Entergy Operations, Inc.

Subject: Arkansas Nuclear One - Unit 2
Docket No. 50-368
License No. NPF-6
Proposed Technical Specification Change Request Regarding Revised ANO-2
Pressure/Temperature and Low Temperature Overpressure Protection Limits for
32 Effective Full Power Years

Proposed Technical Specification Change Request Regarding Revised ANO-2 Pressure/Temperature and LTOP Limits for 32 EFPY

Figure 3.4-2A

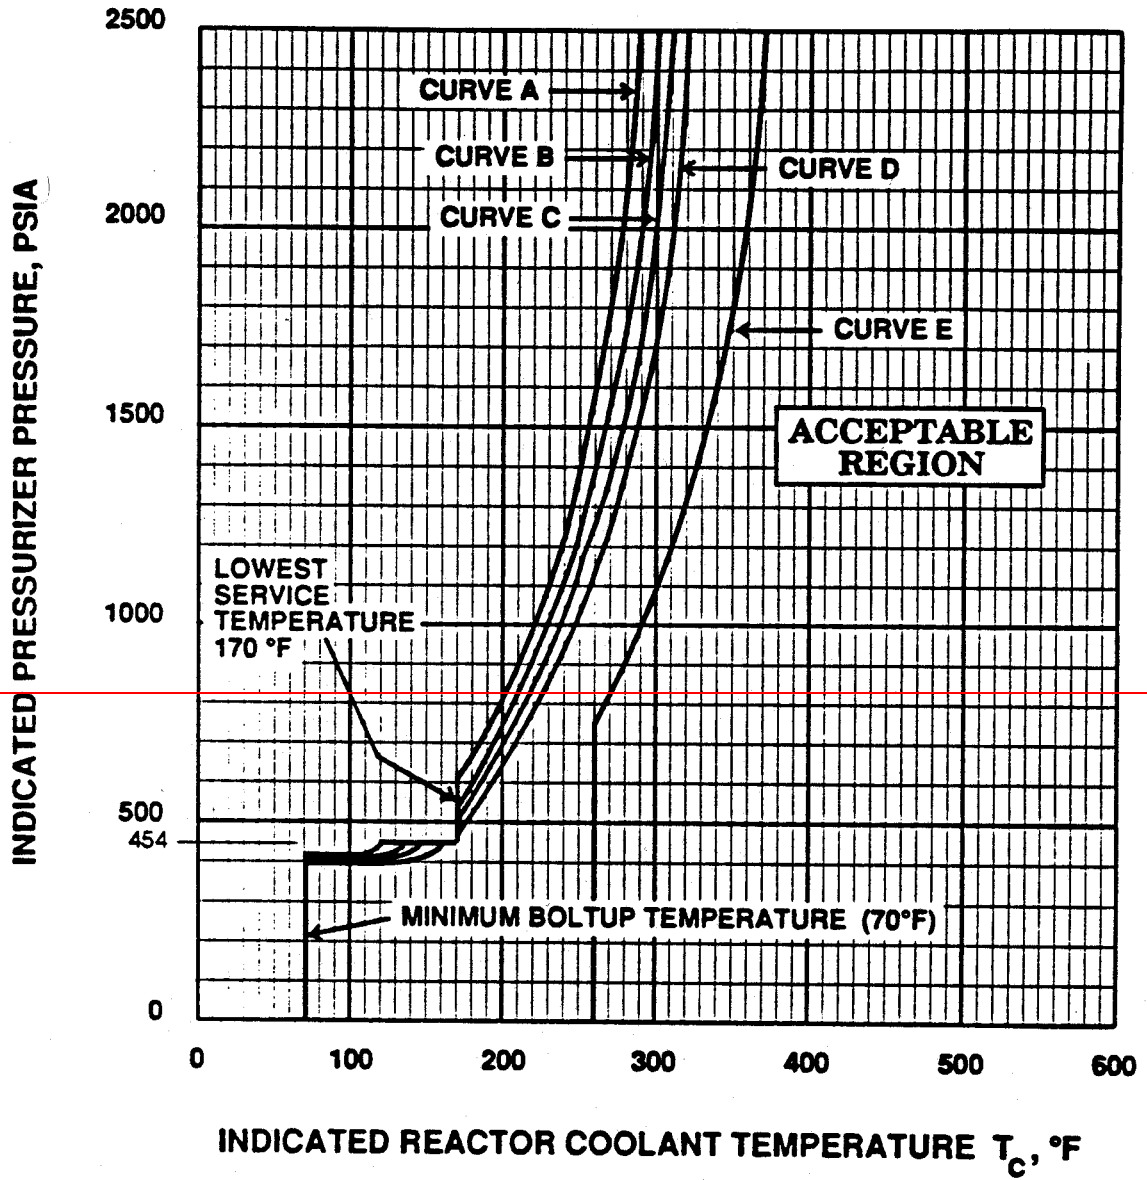
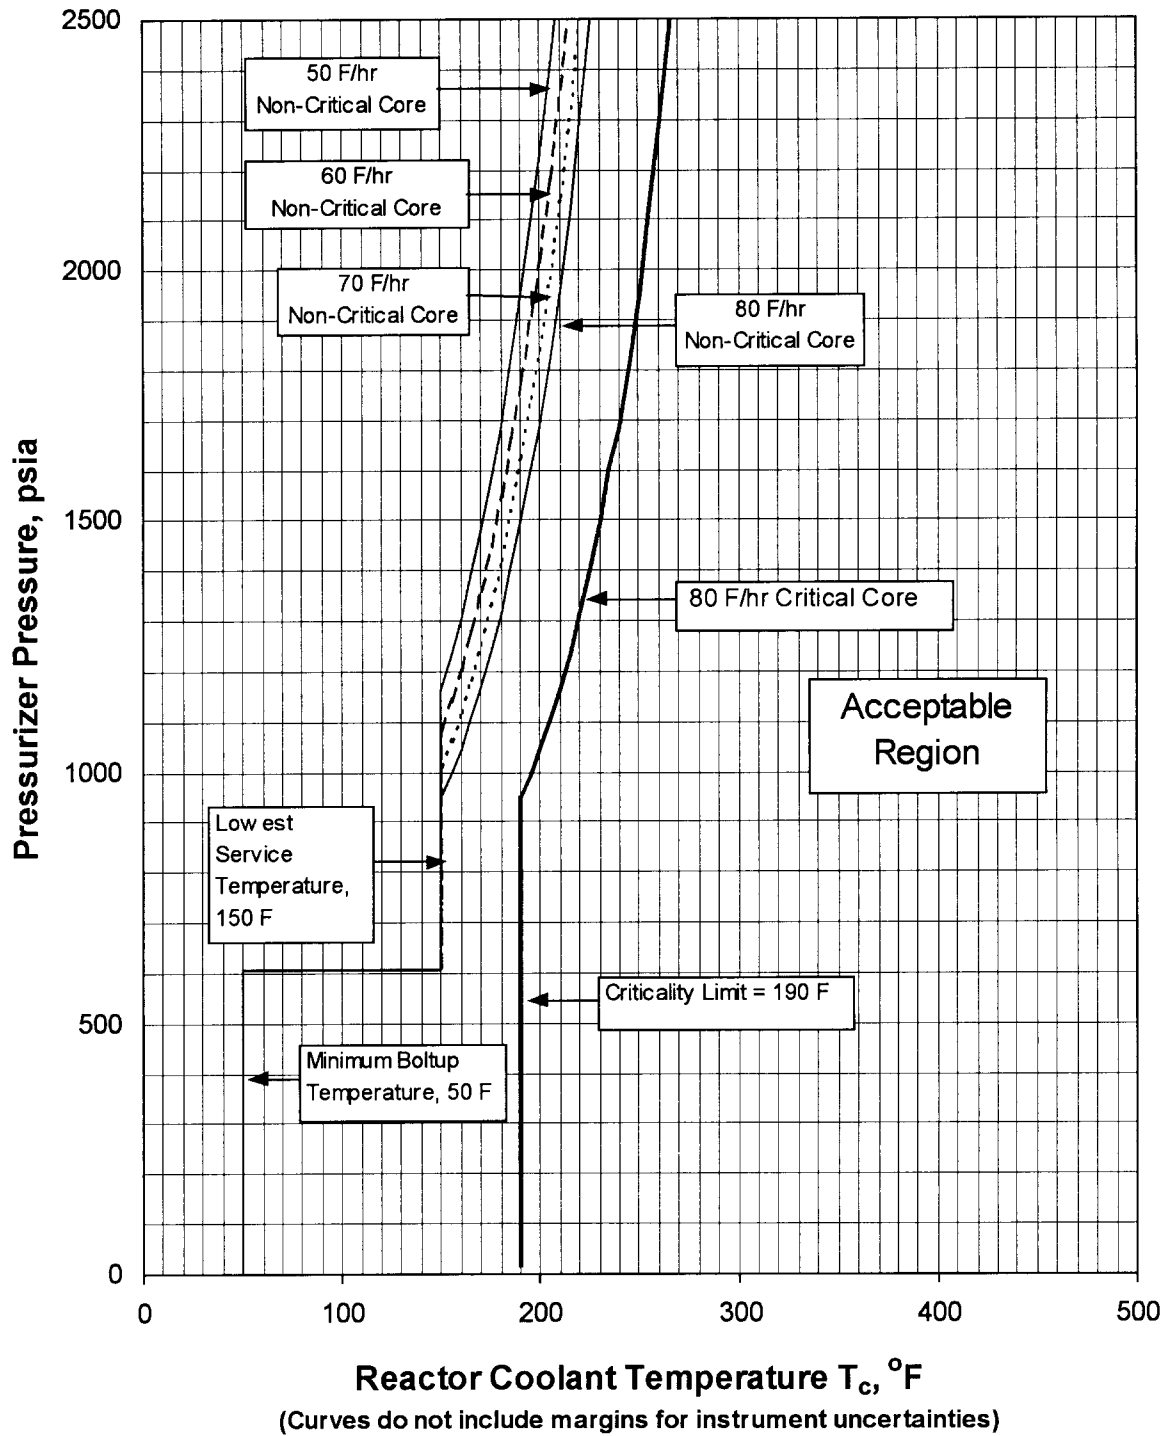
TS LCO 3.4.9.1a: The labeling on the curves as curves A, B, C, and D which represent heatup rates of 50°F, 60°F, 70°F, and 80°F per hour respectively, has been removed from Figure 3.4-2A. Therefore, this labeling scheme is no longer appropriate in the LCO.

TS Figures 3.4-2A, 3.4-2B and 3.4-2C have been revised to reflect new P/T limits for 32 EFPY for heatup/criticality, cooldown, and inservice hydrostatic test conditions, respectively.

(including criticality core limits) at 32 EFPY are provided on the revised TS Figure 3.4-2A. The criticality limit temperature is 190°F, which is based on the RT_{NDT} of the closure flange material (30°F) plus 160°F which is larger than the 175°F value that corresponds to the inservice hydrostatic test limit pressure of 2500 psig. Considering all the ramp and step cooldown transient scenarios, composite cooldown P/T limits for cooldown are shown in TS Figure 3.4-2B. The inservice hydrostatic test P/T limits are shown in TS Figure 3.4-2C. Acceptable pressure and temperature combinations for reactor operation are below and to the right of the pressure-temperature limit curves.

For normal heatup operation, TS Figure 3.4-2A, four ramped heatup transient conditions are considered in the evaluation. These transient conditions are simulated by increasing the reactor coolant system (RCS) cold leg temperature from 50°F to 560°F at constant rates of 50, 60, 70 and 80°F/hr. The inservice hydrostatic test condition contained in TS Figure 3.4-2C is also evaluated using the RCS cold leg temperature ranges, at a ramp rate of 10°F/hr.

a. A maximum heatup of 50°F, 60°F, 70°F or 80°F in any one hour period in accordance with ~~curves A, B, C or D, respectively, in~~ Figure 3.4-2A.

Figure 3.4-2B

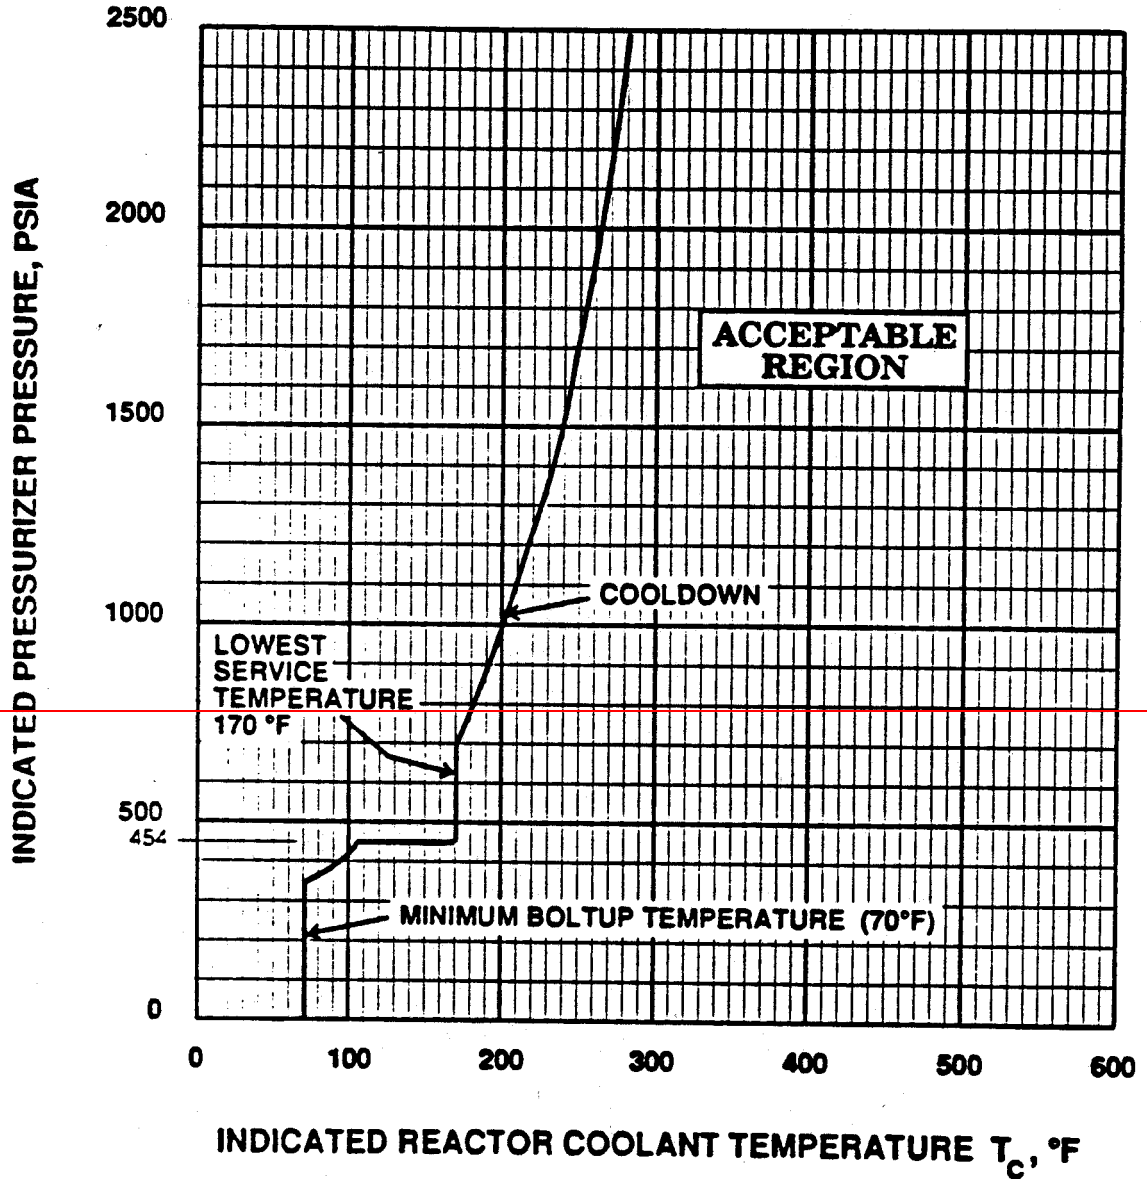
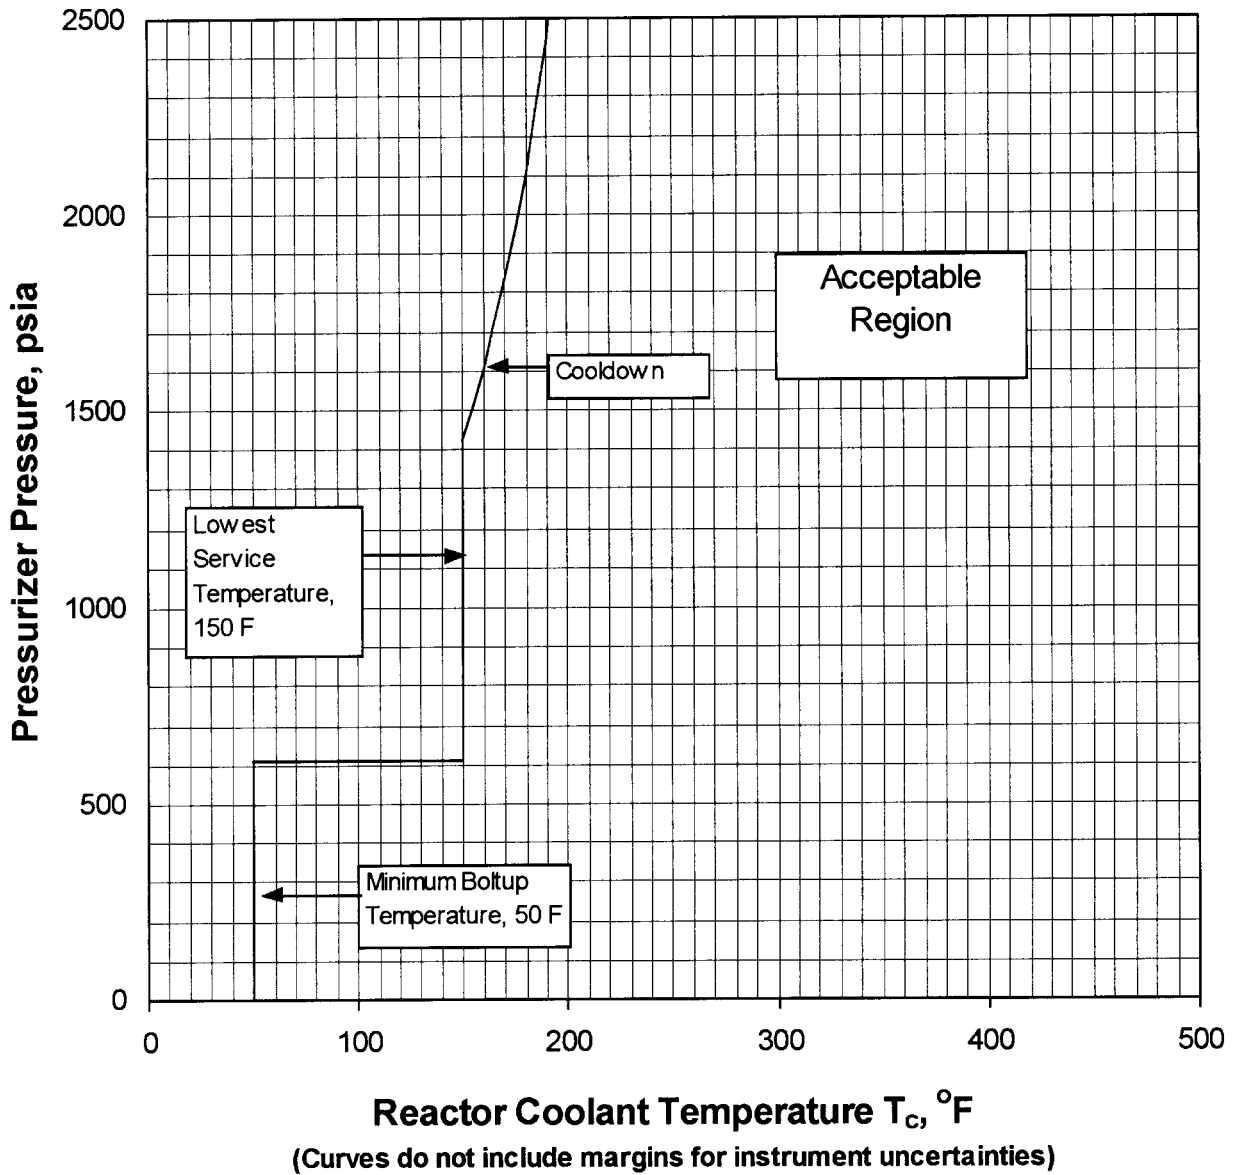
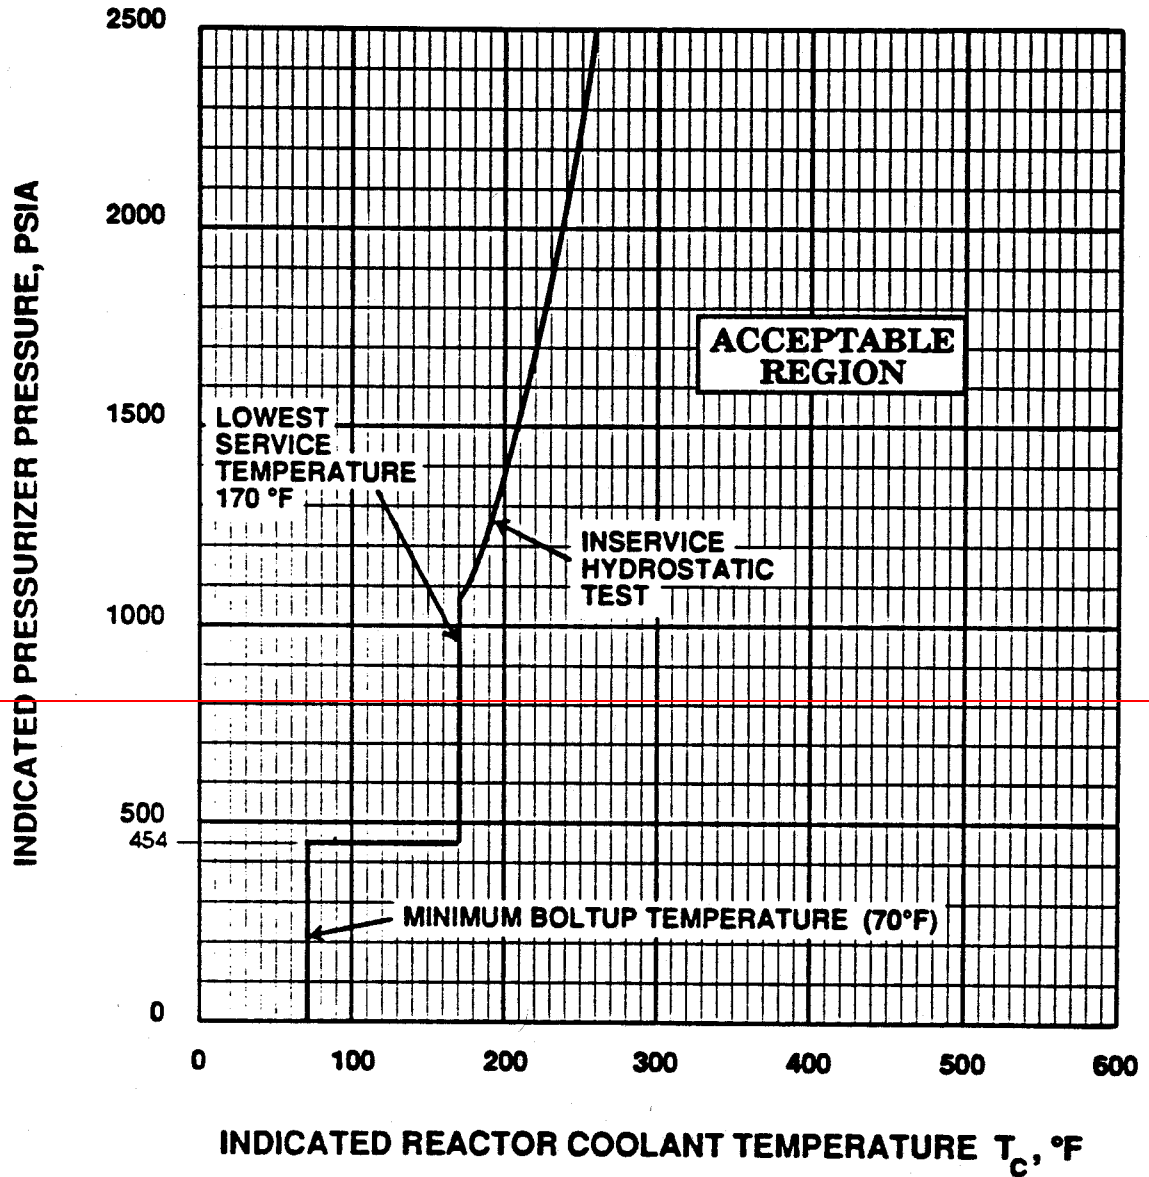
TS LCO 3.4.9.1b: For normal cooldown operation (Figure 3.4-2B) the following temperature dependant rates for ramped (constant) and stepped cooldown transients were used in the evaluation and are reflected in the TS LCO. These analyses are the same as those currently used except that no instrument uncertainty is being applied.

For normal cooldown operation, Figure 3.4-2B, the following temperature dependant rates for ramped and stepped cooldown transients are considered in the evaluation. Except for these cooldown rates not including a margin for instrument uncertainty they are identical to those used in the current TS P/T curves contained in the TSs. The assumptions also include that only two RCPs are in operation while in the LTOP region of the curves consistent with the current TSs.

$200\text{ }^{\circ}\text{F} < T_c$	100°F/hr (constant) or 50°F in any half hour period (step)
$120\text{ }^{\circ}\text{F} \leq T_c \leq 200\text{ }^{\circ}\text{F}$	60°F/hr (constant) or 30°F in any half hour period (step)
$T_c < 120\text{ }^{\circ}\text{F}$	25°F/hr (constant) or 12.5°F in any half hour period (step)

Figure 3.4-2C

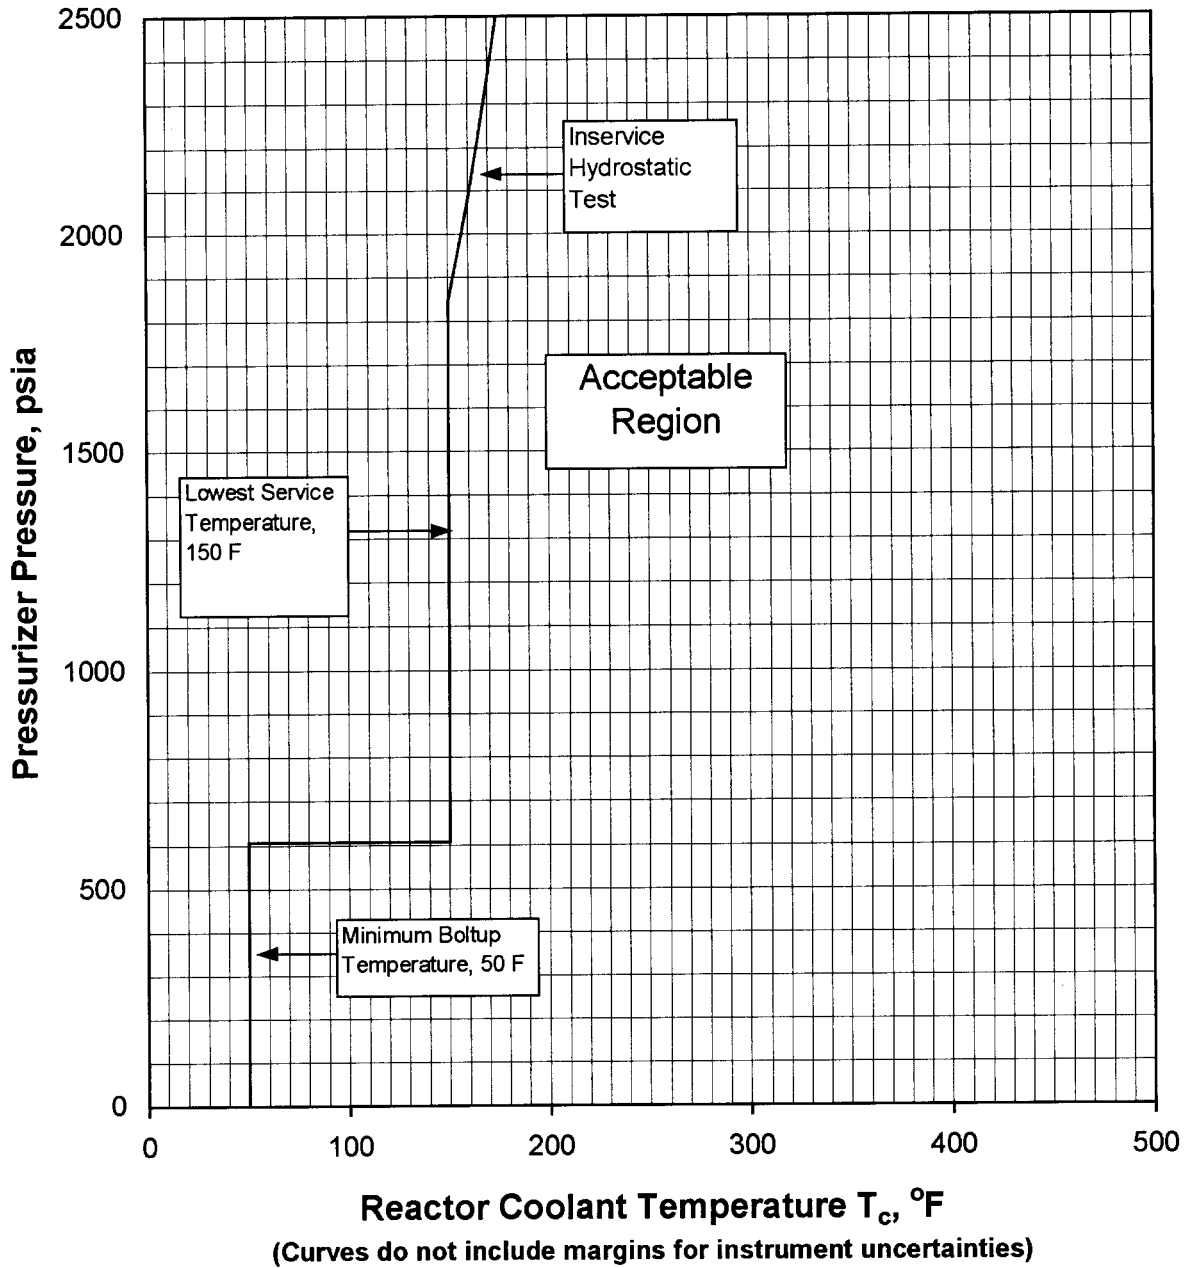
Both 10CFR Part 50, Appendix G and ASME Code Section III, Appendix G, require the development of pressure/temperature limits which are applicable to inservice hydrostatic tests. The minimum temperature for the inservice hydrostatic test pressure can be determined by entering the curve at the test pressure ~~(1.1 times normal operating pressure)~~ and locating the corresponding temperature. This curve is shown for ~~21-32~~ EFPY on Figure 3.4-2C.
